Comments:

REO - LINE CORRECTIONS

Fig. 3

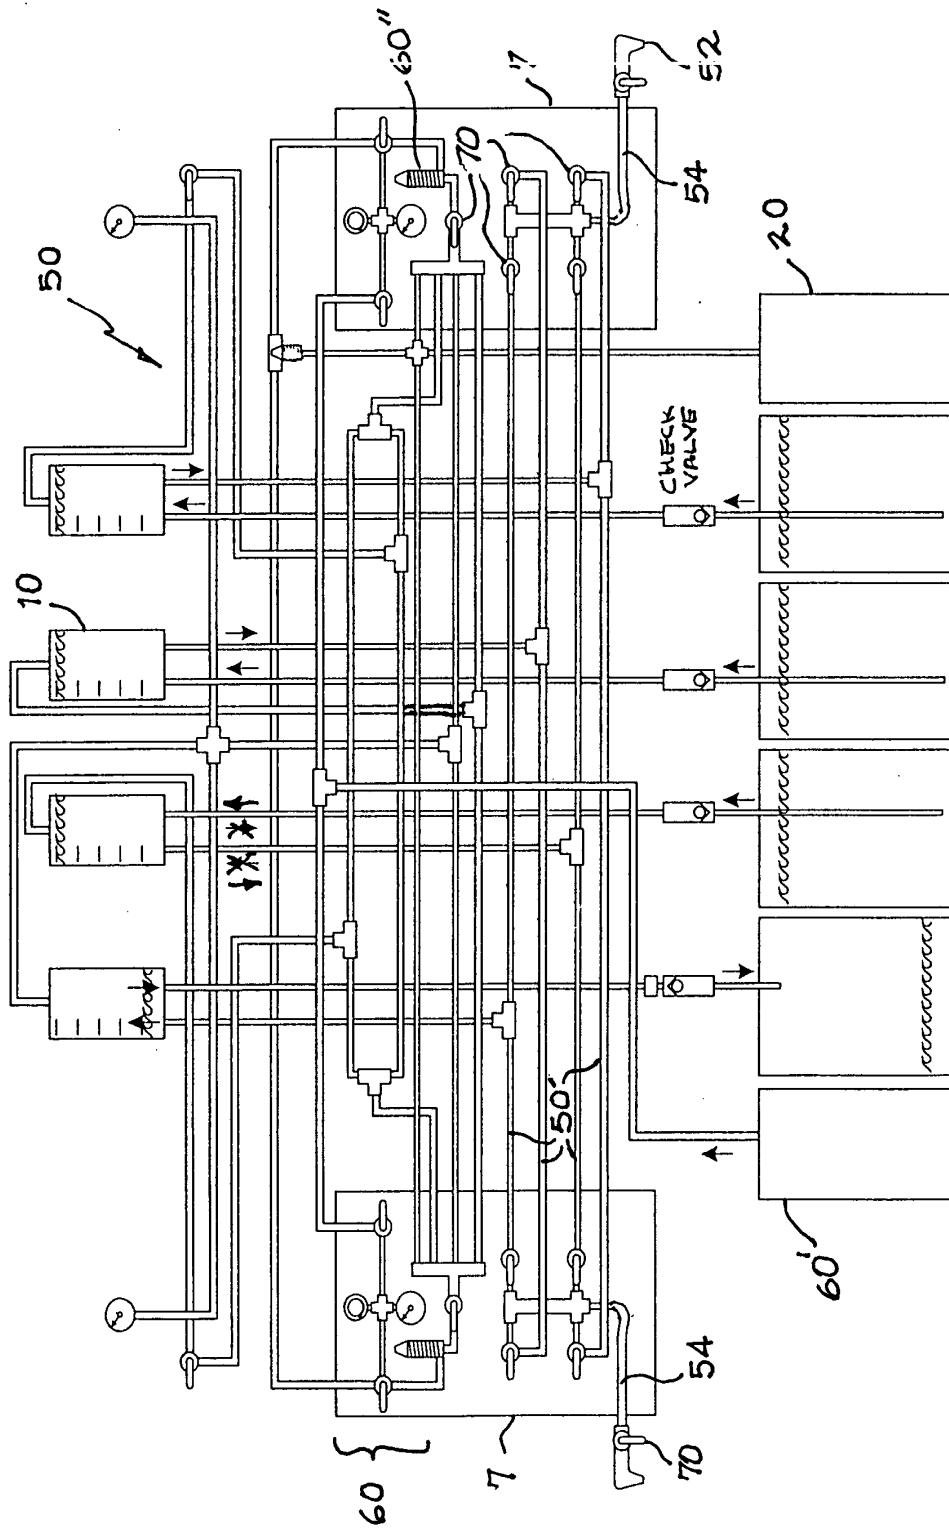
In Fig. 3, there are four tanks (10) shown at the top of the figure. Each of these tanks shows, by arrows, fluid entering on the left and leaving on the right from the bottom of the tank. However, in the second tank from the left the fluid is to enter on the right and leave on the left, and this has been amended in the revised figure 3. This is a drafting error where the arrow senses were inadvertently reversed.

Also, in figure 3, the conduit that extends from the top of the third tank from the left (identified by numeral 10), this conduit terminates shy of its "T" connector which is shown just below the terminal end of this conduit. This has been corrected in this amendment by extending this conduit to connect to the "T" connector, which is shown just below. Again, this is a drafting error where the drafter failed to make connection to the "T" connector.

A replacement sheet showing the corrected figure 3 is enclosed, as well as a red line version showing the corrections. The reference numerals and leader lines have been formalized in all figures.
